ZKE TECH EBC-A05 DC electronic load Bug report

Make by Roland Tóth date.: 2017. April .17 e-mail.: rendszergazdanyh@citromail.hu

"EB Software Tester V1.8.5 (Build 2016-03-20)"

"ZKE perform DC CHARGER & EBC-A05"

(3. picture)

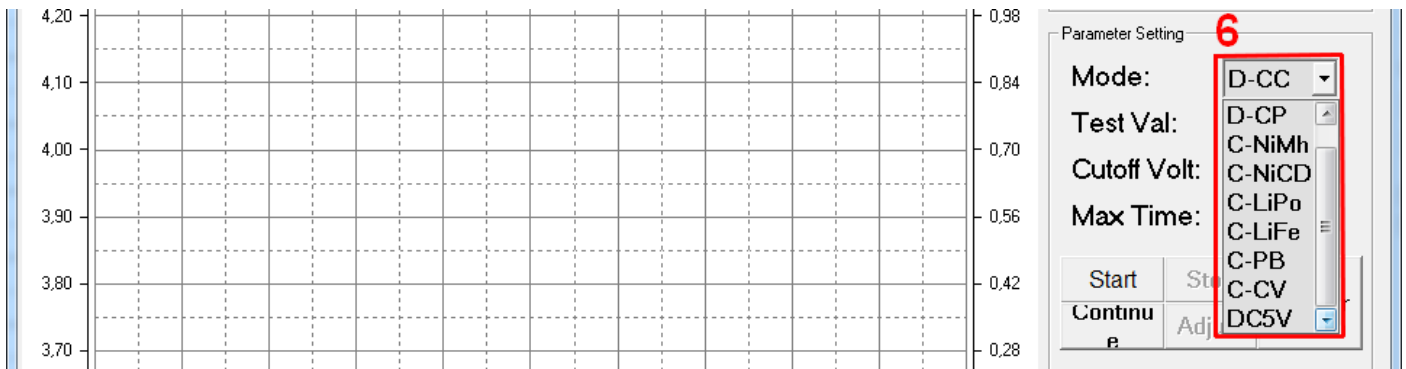
List of errors in the third picture.

1. The program that is marked in capital letters "M". The time is marked with a small unit "m". Please fix it.
2. The "Start" button plain text type.
The other button (**Stop**, **Monitor**, **Continue**, **Adjust**) text in bold type.
Replace "Start" button type of bold text.
3. "Continue" text does not fit into the button. Increase the width of the button.
4. The "Disconn" button is missing from the end of the text.
Please replace the text of the button "Disconnect".
And if necessary, the button to increase the width to fit into.
5. The "CurveA" is out of the cell. Please increase the cell width to fit into the text.
The "CurveA" and the text should be written separately. Please replace the "Curve A"
The same applies to "CurveV" text. Please replace the "Curve V"
And the cell width to adapt to the new text.

(5. picture)

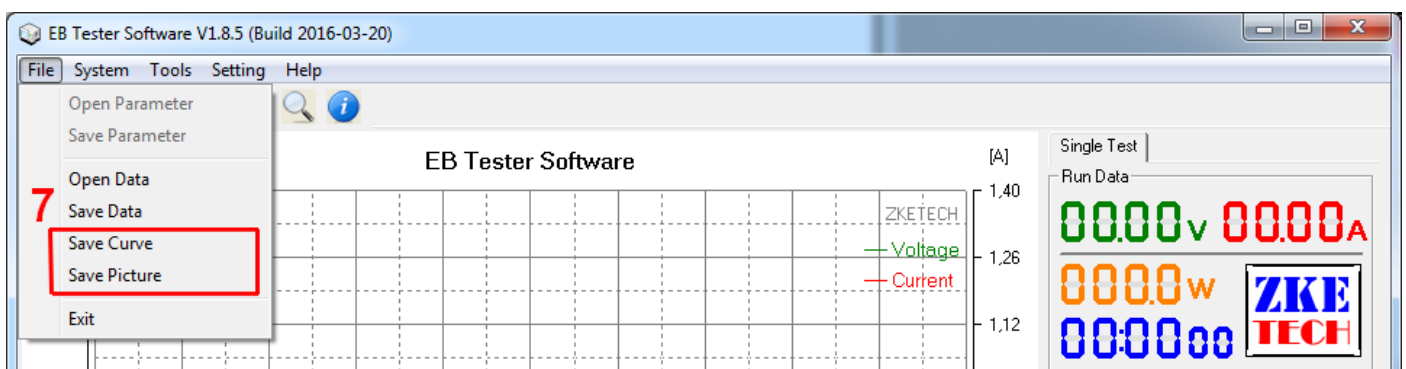
- The curve and image is saved only in ***.BMP** format, which occupies a large space.
If possible, the program will save the ***.PNG** image format.
An image saved in ***.BMP** format (FullHD mode 1920x1080 pixel) more than 4 Mb.
Same converting images to ***.PNG** format, smaller than 100 Kb.

(6. picture)

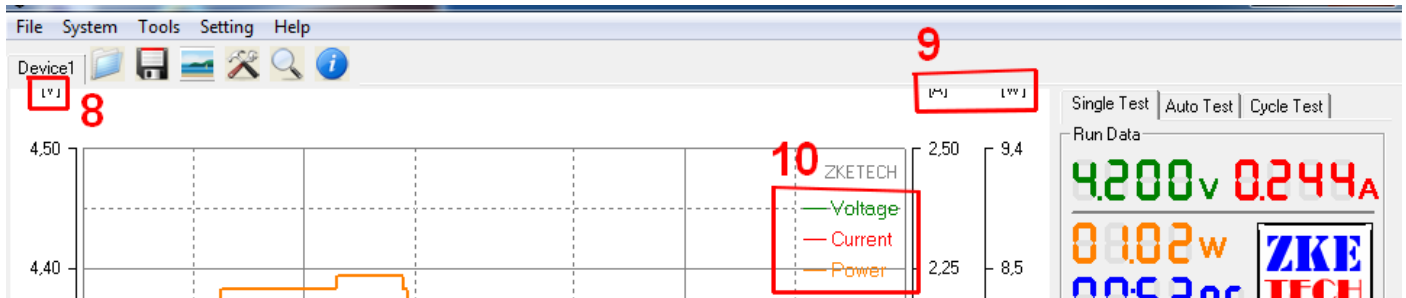
- After increasing the height of the window or full-screen mode, the graph markers "V" sticking out of the window. Please fix it.
- After increasing the height of the window or full-screen mode, the graph markers "A" and "W" sticking out of the window. Please fix it.
- The graph lines interfere with the "Voltage" and "Current" and "Power" text readability. The text are moving to a position where it is not about lines.

(7. picture)

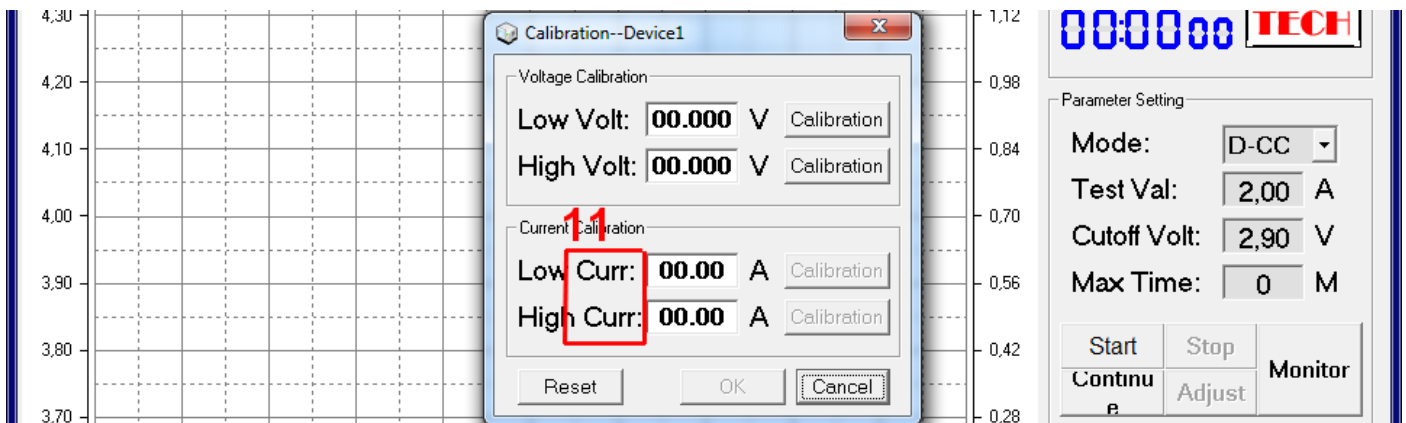
- System menu, Calibration parameters window, the end of the "Curr" is lagging behind. Please replace "Current" text, and resize the actual window.

(8. picture)

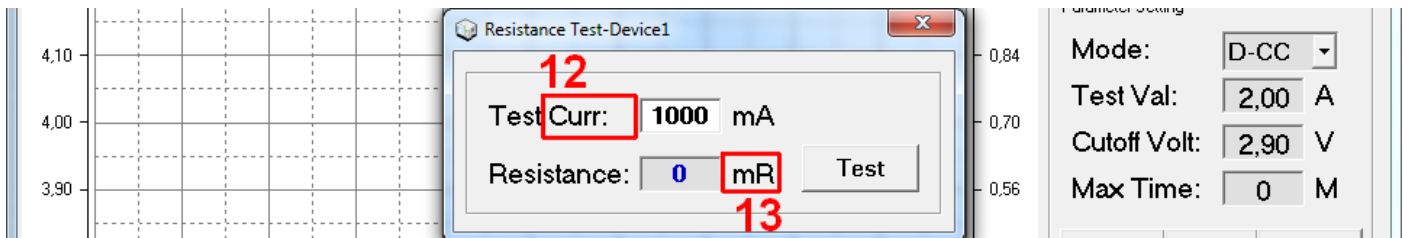
12. Tools menu, Resistance Test window, the end of the "Curr" is lagging behind.
Please replace "Current" text.

13. The resistance "mR" wrong unit of measure. Omega write correctly.
The milliohms correct unit of measure called "mΩ", please replace.

(9. picture)

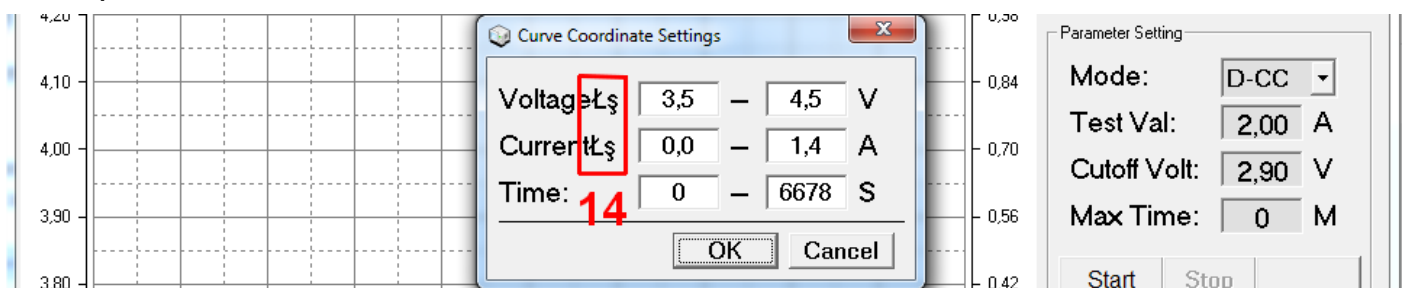
14. Setting menu, Coordinate Settings window, "Voltage" and "Current" after the words are meaningless characters.
Please replace the meaningless characters to colon character.

(10. picture)

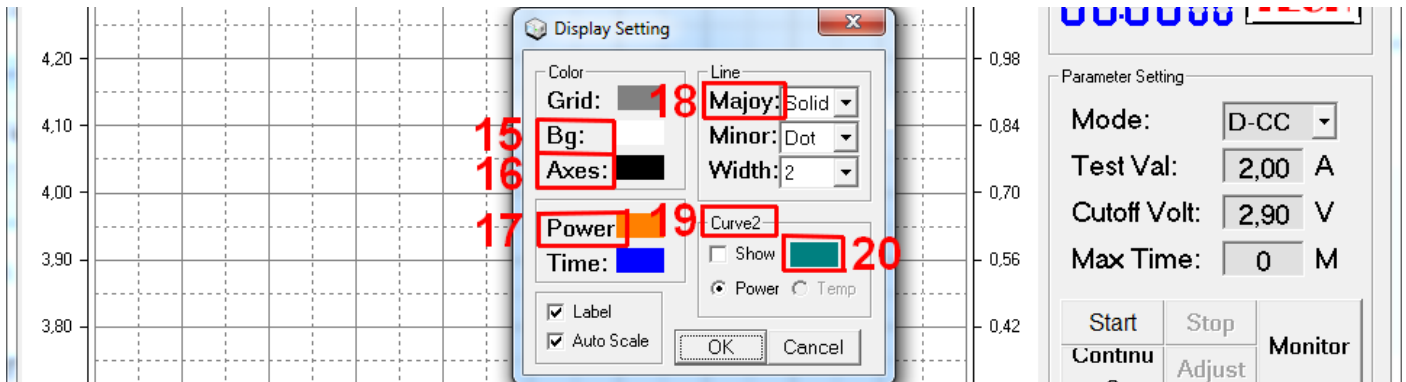
15. Setting menu, Display Settings window, "Bg" text is misinterpreted.
Please replace the text "Background", and resize the actual window.

16. The "Axes" text is misinterpreted. Please replace the text "Axis"

17. After the "Power" text is missing the colon character.
Or it is not shown, because the color object is blocked. Please fix it.

18. The "Majoy" text is misspelled. Correctly written, "Major", please replace.

19. The text "Curve2" is misleading.

A more precise term such as "Power curve" or "Third Curve".

20. If you change the "Power curve" color, and closes the window, the color changes.

But if I open this window again, the "Power curve" returns to its default color green. If you enable the "Power curve" display of the curve displayed in the graph. If the program is closed and restarted, the "Power curve" does not appear. It must be enabled again. The program does not remember the settings.

(11. picture)

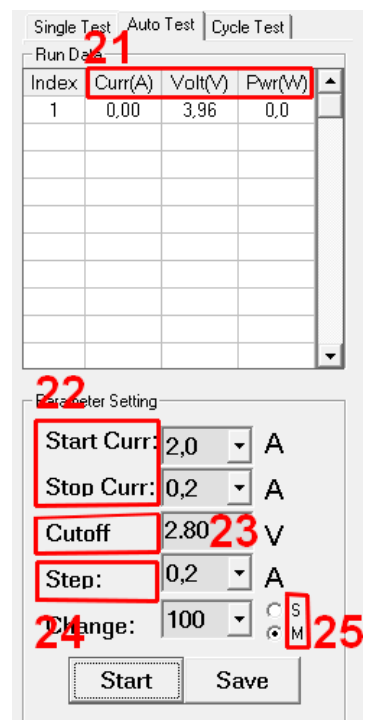
21. The cells do not have the name of your values.

Suggested names instead of the use of the marking.

Instead of "Curr (A)" using "I (A)",

instead of "Voltage (V)" using "U (V)",

instead of "Pwr (W)" using "P (W)".

Or write the correct name,

and increase the cell width to fit into text.

22. The "Start Curr:" and "Stop Curr:" end of text missing.

Please change the text "Start current:" and "Stop current:"

23. After missing the name "Cutoff" text, and colon character.

Please change the text "Cutoff voltage:"

24. The "Step:" text font lower leg "p" is not visible. Please fix it.

25. The unit of time is marked correctly lowercase.

Please "S" and "M" to exchange letters "s" and "m" letter.

*The above picture shows the values of the test starts,

but stops and can not run.
